UNITED STATES PATENT AND TRADEMARK OFFICE

APPLICATION NO.	FILING DATE	FIRST NAMED INVENTOR	ATTORNEY DOCKET NO.	CONFIRMATION NO.
10/047,534	01/15/2002	Brian A. Urbach	TRW(M)5857	4987

Office Action Summary

DETAILED ACTION

5,062,655

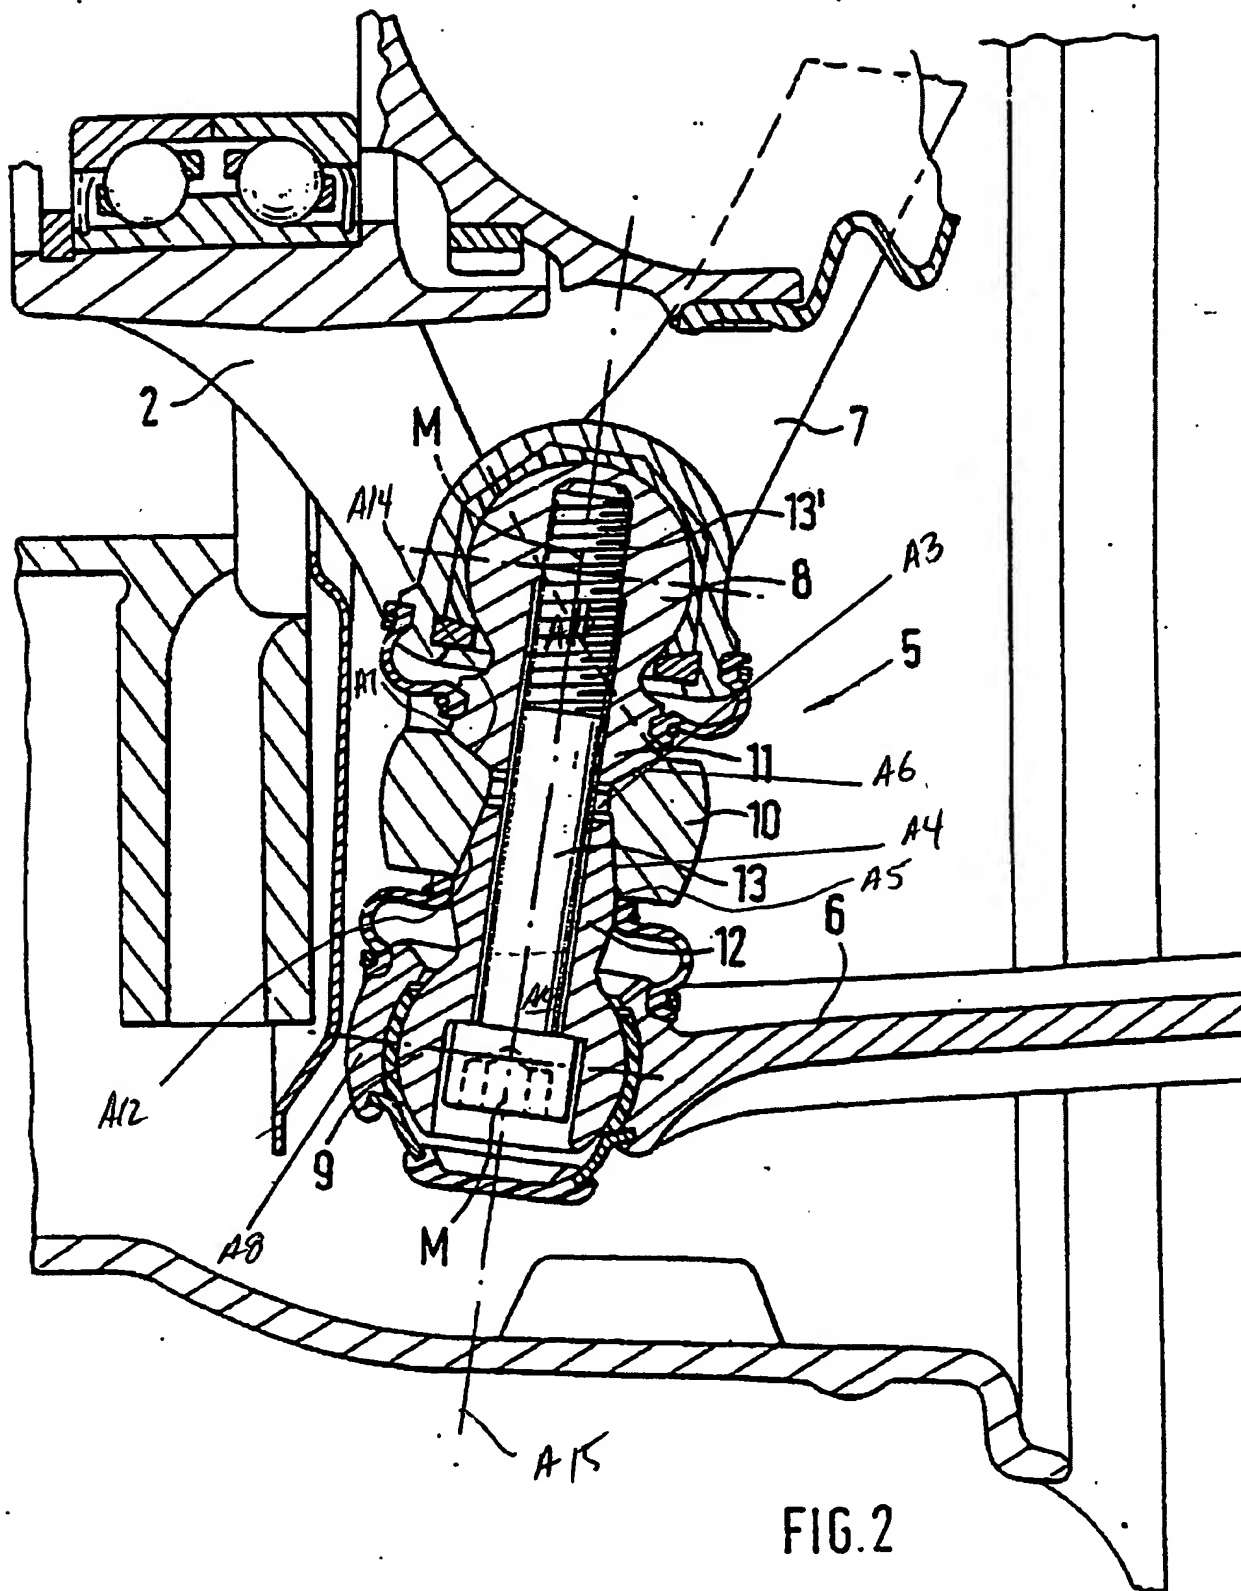
Claims 1-3, 6 and 8 are rejected under 35 U.S.C. 102(b) as being anticipated by Sommerer, 5,062,655 (see marked-up attachment).

Regarding claim 1, Sommerer discloses in Figure 2 an apparatus comprising a first suspension member 6, a second suspension member 10, a socket A8, a stud 13, and a fastener 8.

The second suspension member **10** has a through hole **A3** with a first tapered surface **A4** and a second tapered surface **A6**. The first tapered surface **A4** defines a first end **A5** and the second tapered surface **A6** defines a second end **A7**.

The socket **A8** is connected with the first suspension member **6**.

The stud **13** has a first end portion **A10** and a second end portion **A11**.

The socket **A8** supports the first end portion **A10** in the socket **A8**.

The second end portion **A11** projects from the socket **A8** and has a tapered outer surface **A12** in engagement with the first tapered surface **A4**.

The fastener **8** is on the second end portion **A11** of the stud **13**. The fastener **8** has a tapered outer surface **A14** in engagement with the second tapered surface **A6** of the second suspension member **10**.

The socket **A8** and the stud **13** support the first suspension member **6**.

Regarding claim 2, the stud **13** has a longitudinal central axis **A15** on which the tapered outer surface **A12** of the stud **13** is centered. The tapered outer surface **A12** of the stud **13** extends at a first angle to the central axis **A15**. The first tapered surface **A4** and the second tapered surface **A6** of the second suspension member **10** extend at the first angle to the central axis **A15**.

Regarding claim 3, the tapered outer surface **A14** on the fastener **8** extends at the first angle to the central axis **A15**.

Regarding claims 6 and 8, the second end portion **A11** of the stud **13** has a cylindrical portion extending from the tapered outer surface **A12** of the stud **13** in a direction away from the first end portion **A10** of the stud **13**. The cylindrical portion has a diameter smaller than a smallest diameter of the tapered outer surface **A12** of the stud **13**.

Regarding claim 4, Sommerer, as discussed above, fails to disclose the tapered outer surface **A12** on the stud **13** extends at a 45 degree angle to the central axis **A15**. It would have been obvious matter of design choice to make the angle extend at 45 degrees or any other angle as the angle can be varied to design. Therefore, it would have been obvious to one of ordinary skill in the art at the time the invention was made to make the angle be 45 degrees as part of a design choice.
